ADDENDUM NUMBER

02

March 15, 2024

**PROJECT: MORGAN COUNTY EVENTS CENTER
ARCHITECT: GOODWYN MILLS CAWOOD
OWNER: MORGAN COUNTY COMMISSION**

G1.21

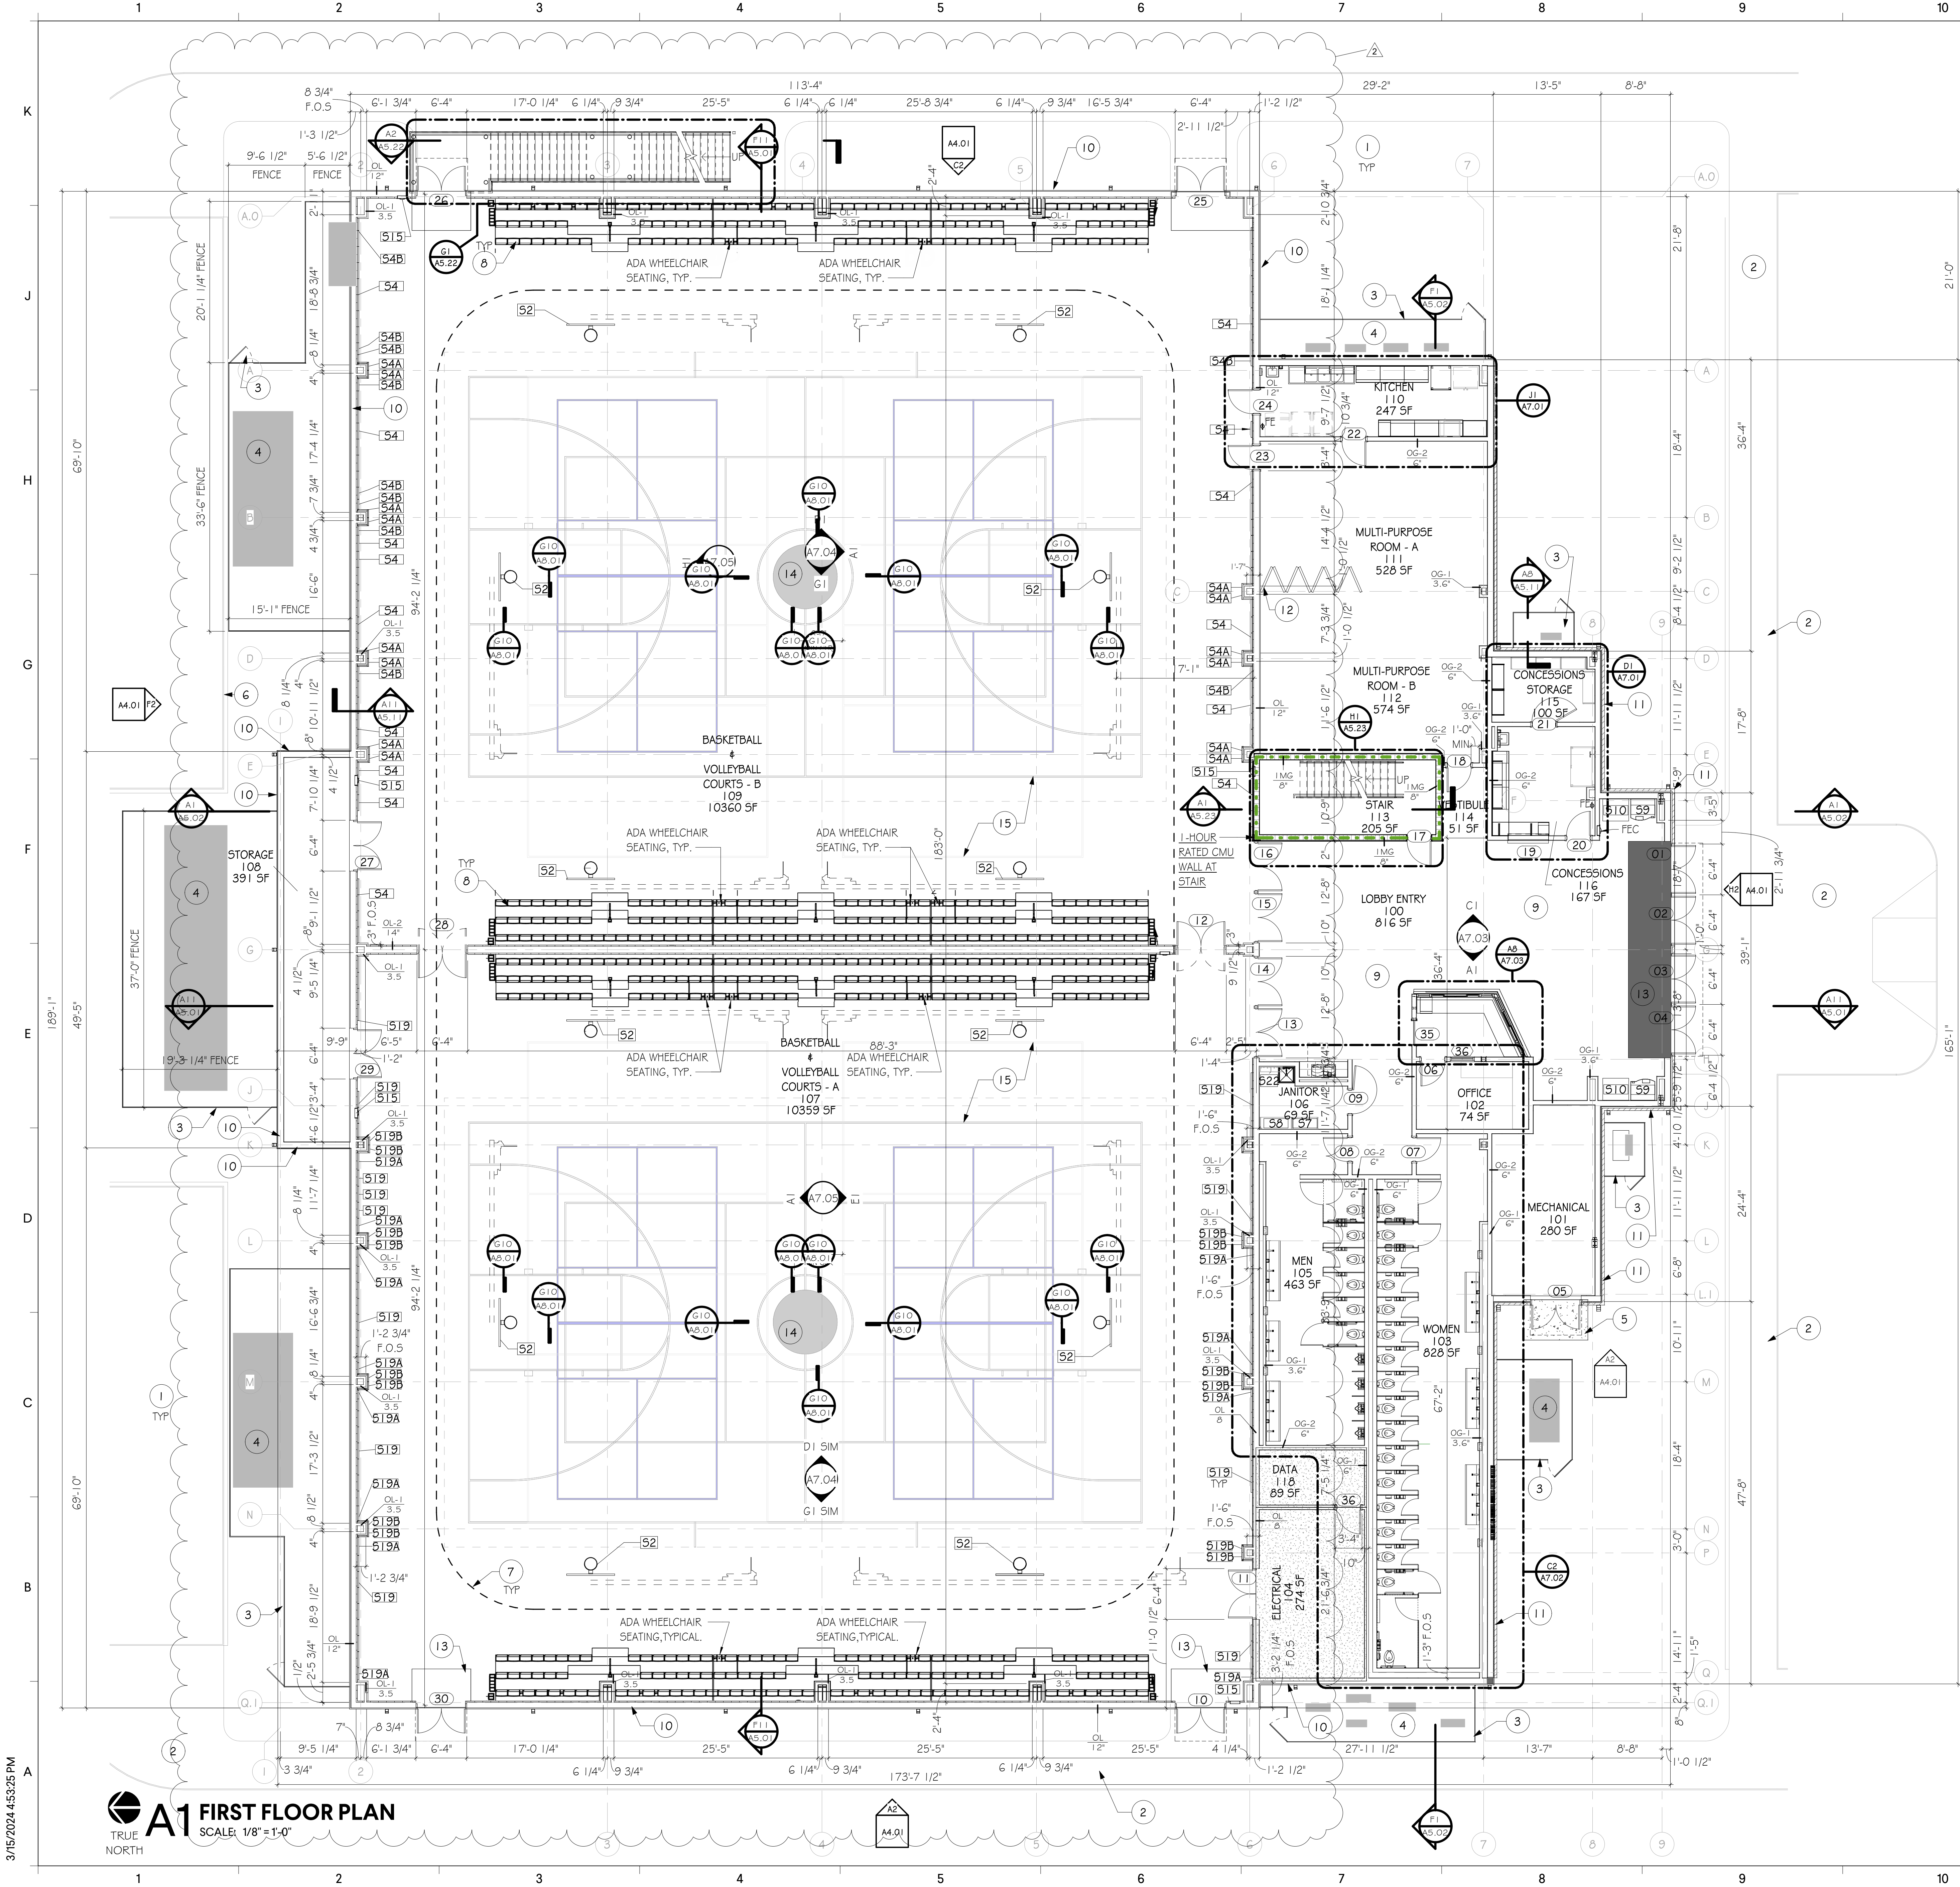
| REQUEST FOR INFORMATION LOG | | | | | | | | | |
|-----------------------------|-------|---------------|----------------|-----------|--|-----------------------------------|---|--|-----------------|
| 15 | | | | 3/7/2024 | Sheet A1.01 Keynote 10 indicates 8.5" metal studs. Metal stud standard sizes are 8" and 10". Is 8.5" correct? Will the PEMB components take care of this wall type? Please clarify. | Limestone Building Group | It is 8. See revised wall type sheet Addendum 2 | | |

1 VINYL (HVAC) FENCING

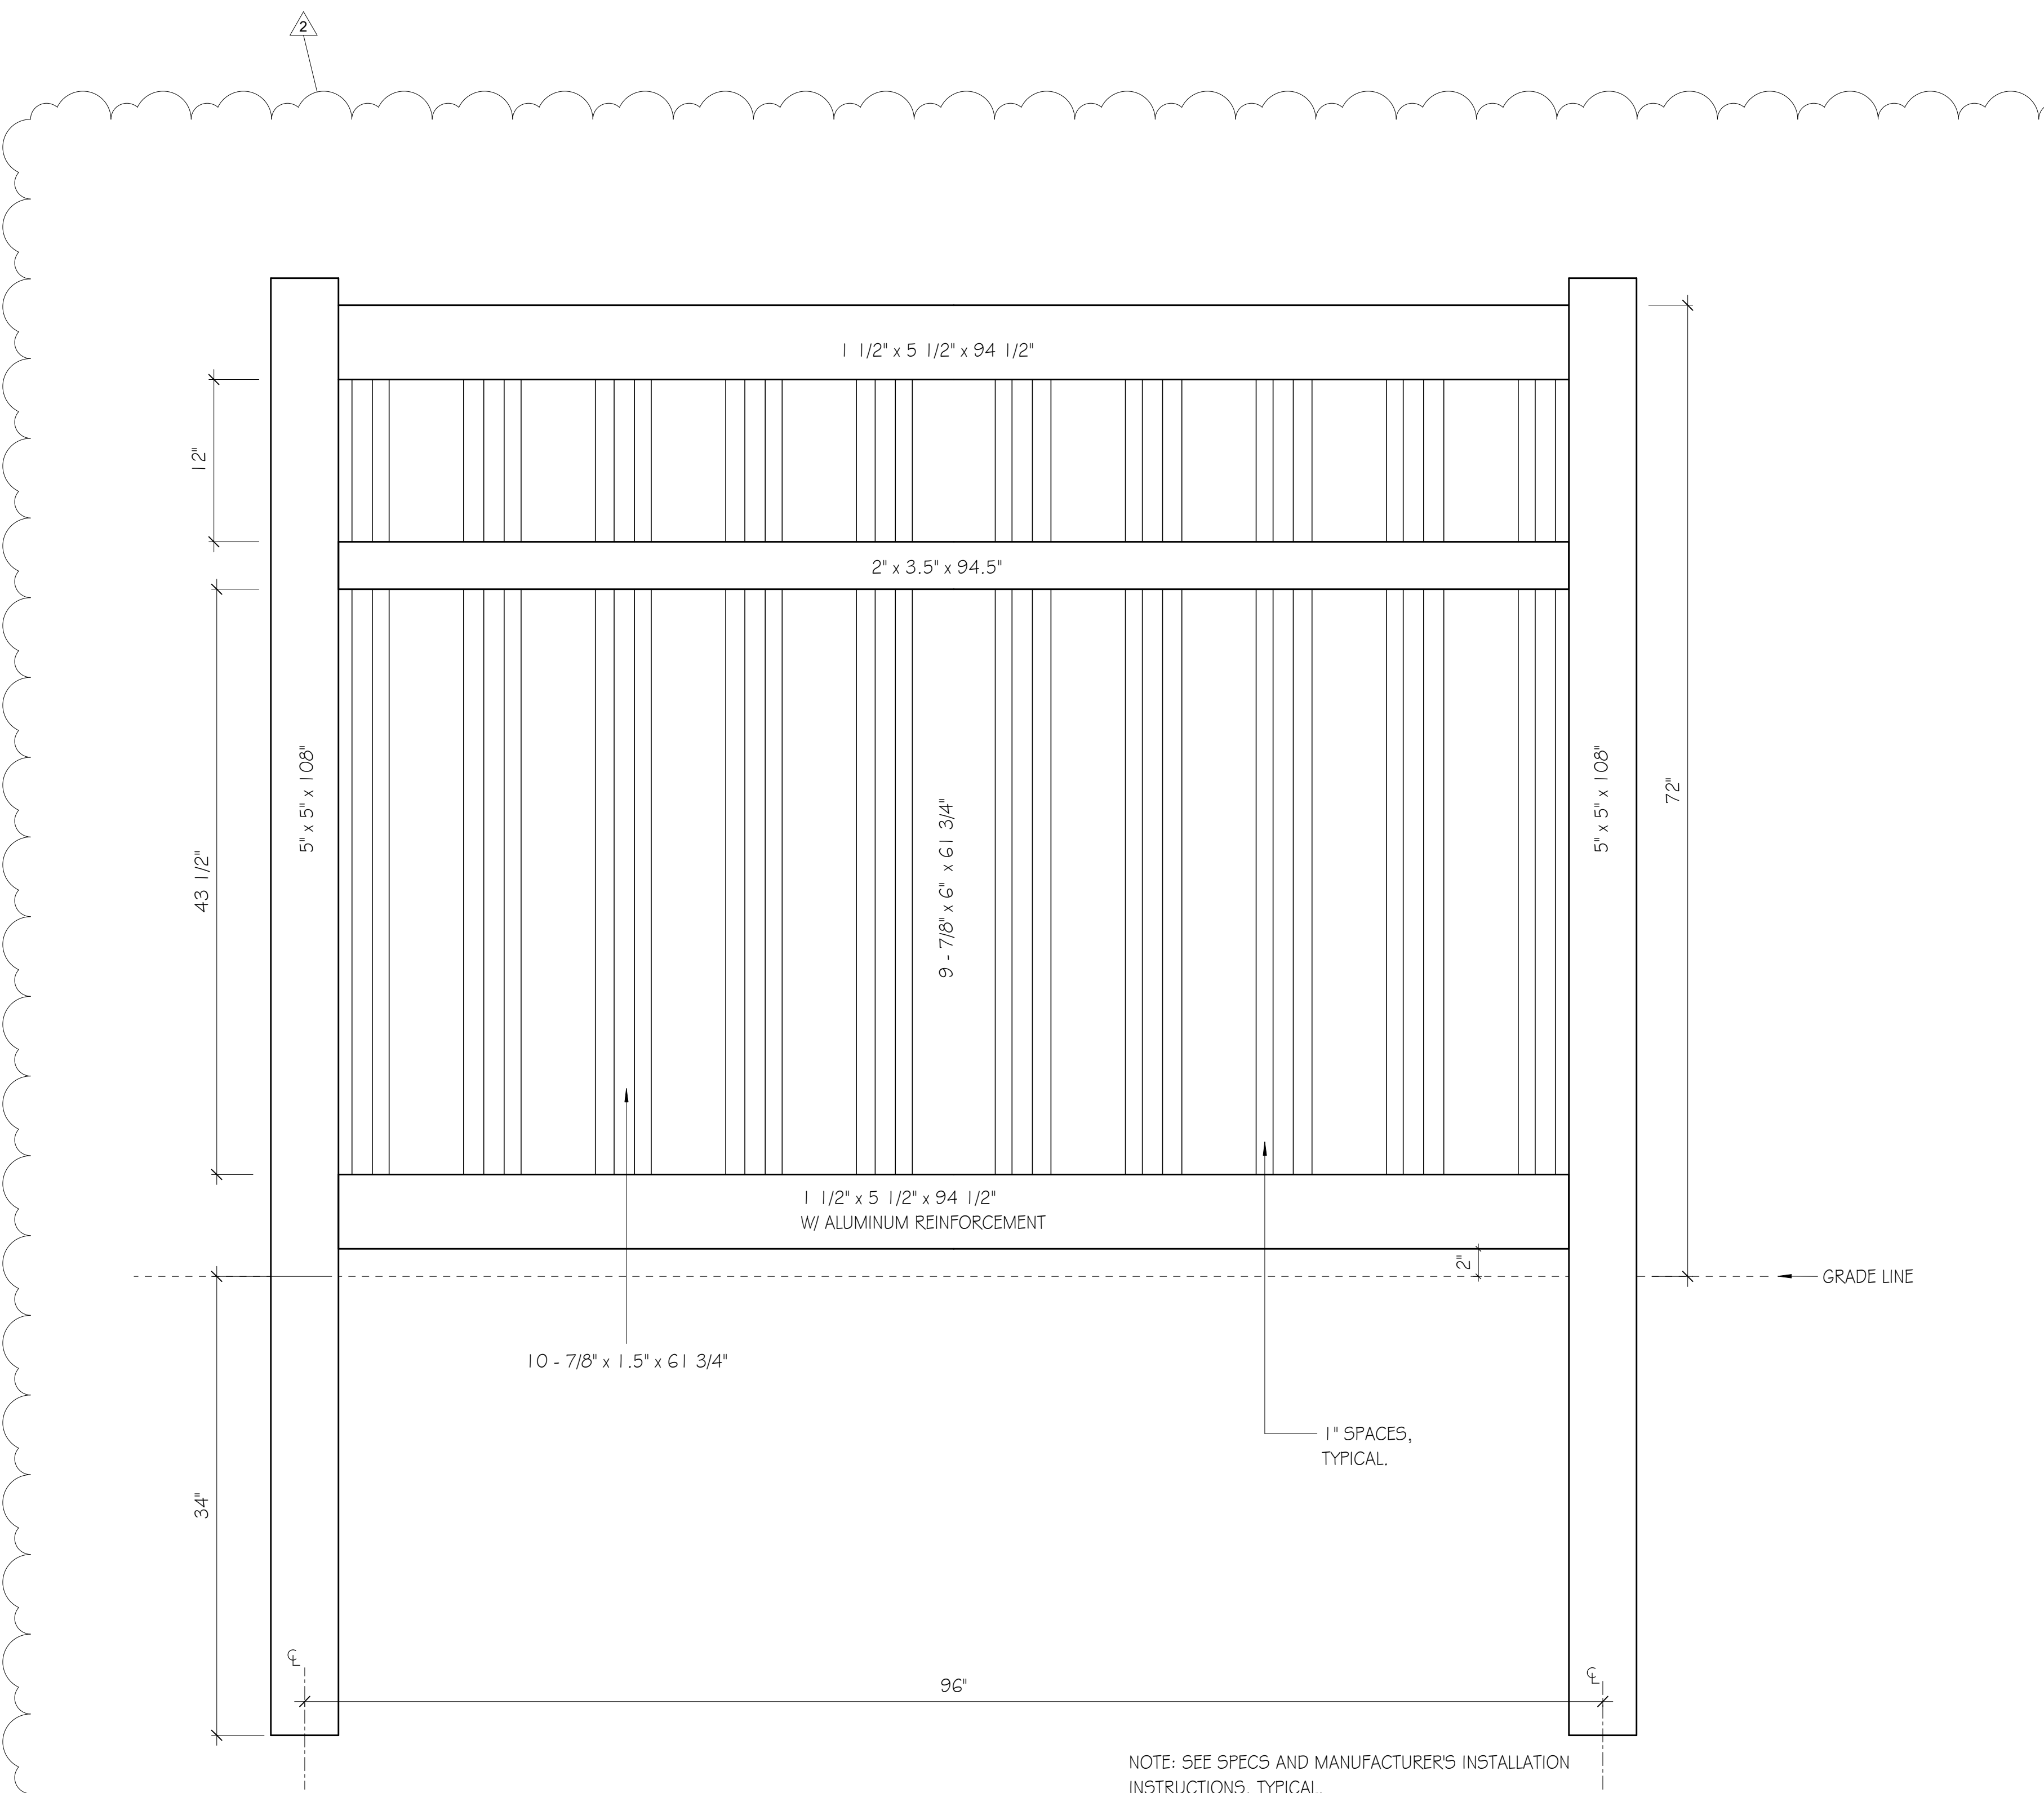
| REQUEST FOR INFORMATION LOG | | | | | | | | | |
|-----------------------------|-------|---------------|----------------|-----------|--|-----------------------------------|---|--|-----------------|
| 6 | | | | 3/4/2024 | 1. Is there an official RFI Form to be used for Pre-Bid RFI's? The specs Table of Contents lists one but we are unable to locate the form in the specs. 2. Please provide specifications for Pre-Engineered Metal Building. 3. Please provide specifications for Metal Canopy. 4. Please provide Finish Hardware specification. 5. Please provide detailed description of NIC sitework and what sitework is in the contract. 6. Spec section 064000 – can the AWI certifications be waived? 7. Please provide detail and/or elevation specification for vinyl HVAC fence shown on sheet A1.01. | Limestone Building Group | You can send RIFs on your form or by email. See Addendum 1 for PMB spec and site work clarification. The fence spec and detail is in Addendum 2. | | |
